Notice of Modification

Section 75W of the *Environmental Planning and Assessment Act 1979*

SCHEDULE 1

The development consent (DA 128-5-2005) granted by the Minister for Planning on 21 December 2005 for the development of the Lynwood hard rock quarry and associated infrastructure, located west of Marulan, in the Goulburn Mulwaree local government area.

FIGURE 3.3
Indicative Year 30 Quarry Plan

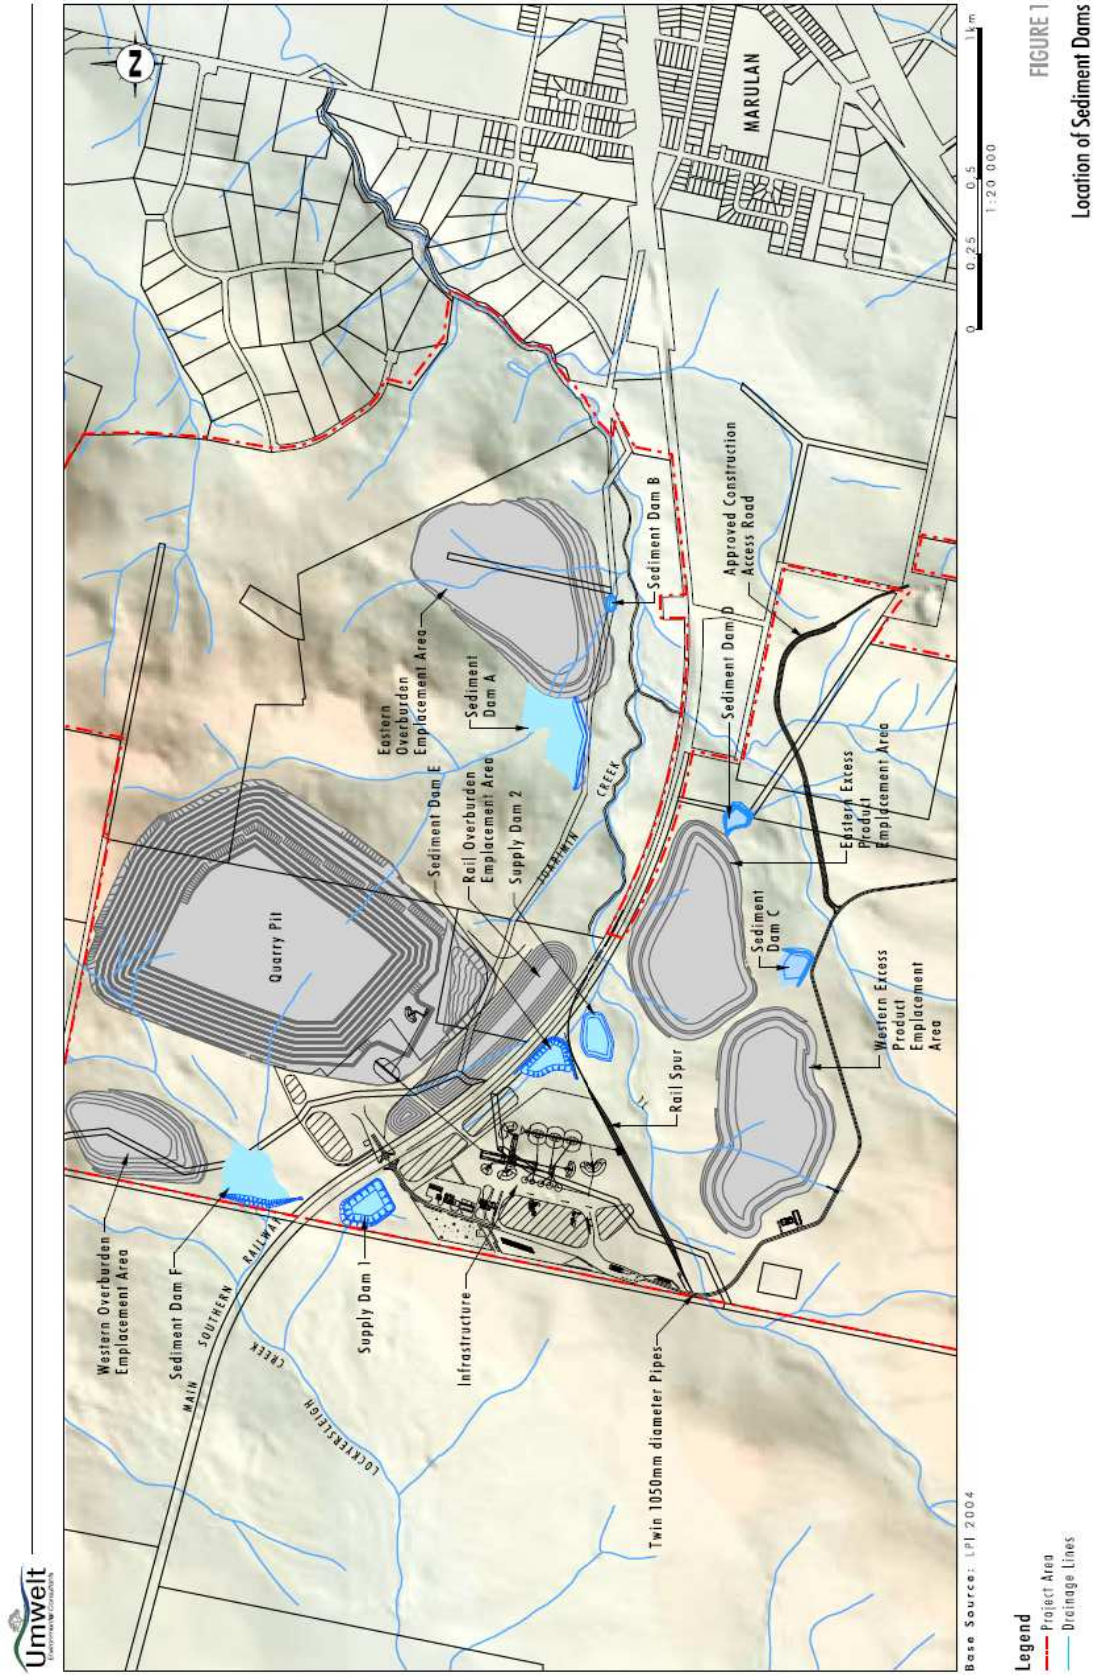
12. Delete Appendixes 1, 2, 4, 5, 6 and the first figure of Appendix 8 and replace with the following:

APPENDIX 2: LIMITS OF EXTRACTION

Construction Traffic Routes Through Marulan Township

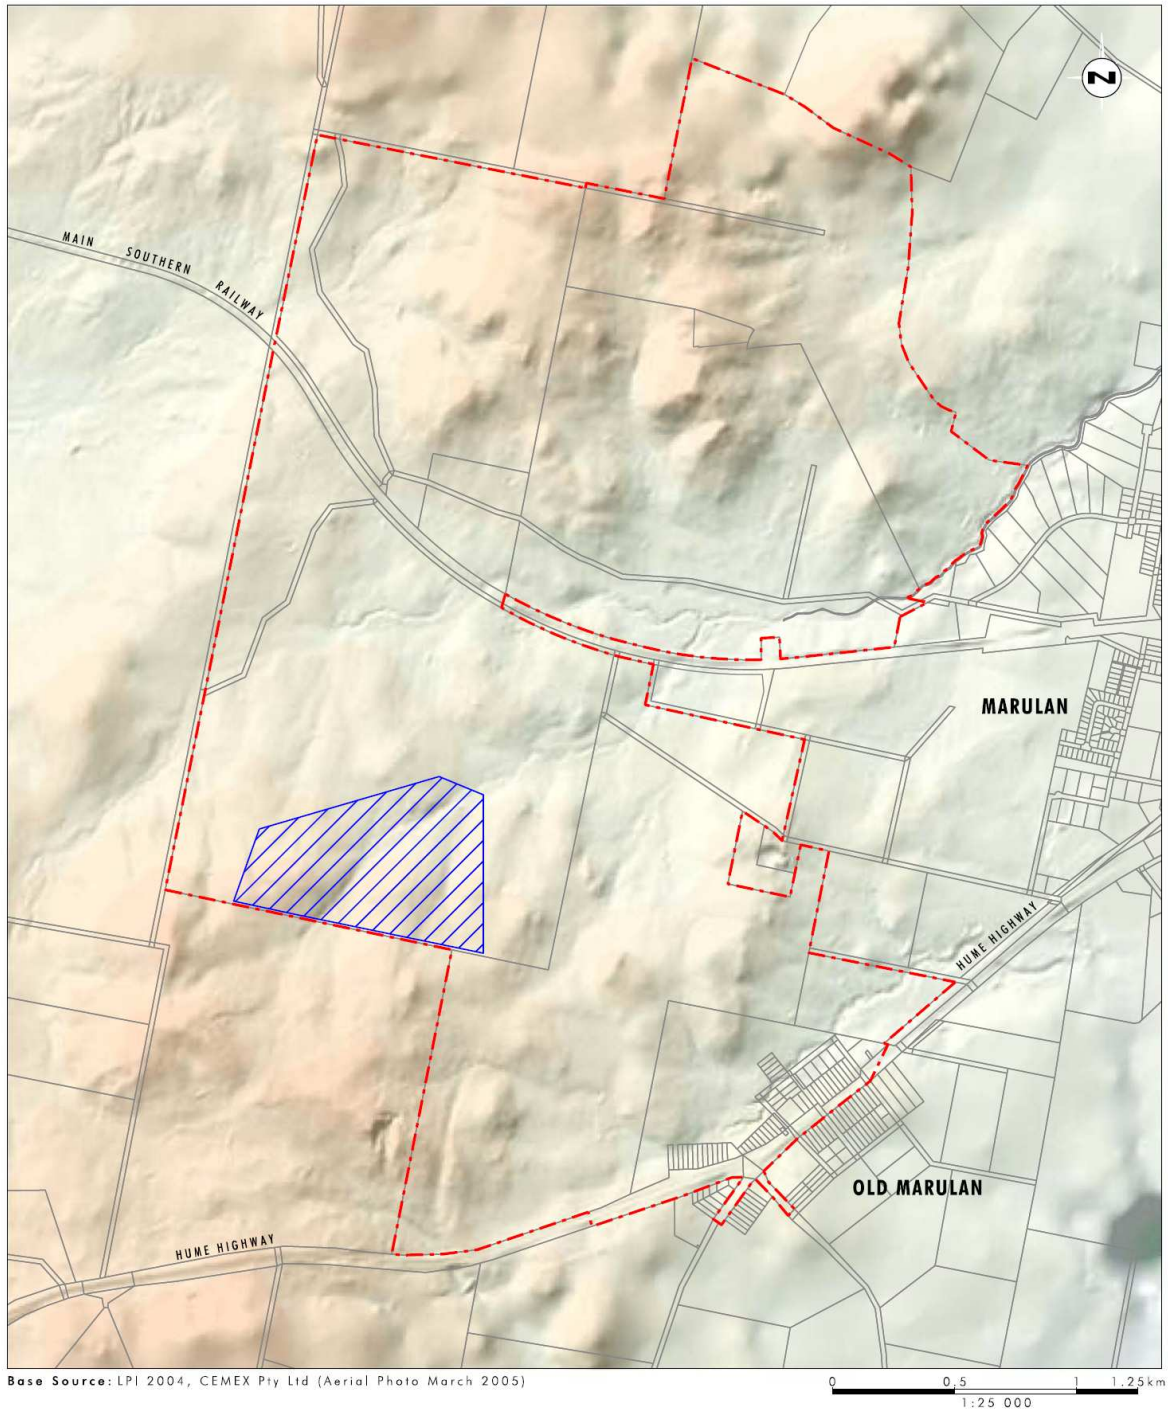
- Note: The temporary construction access routes are shown in Appendix 5. The requirements of this condition are to be reflected in the Construction Traffic Management Plan required under condition 28 below.*

APPENDIX 5: CONSTRUCTION TRAFFIC ROUTES
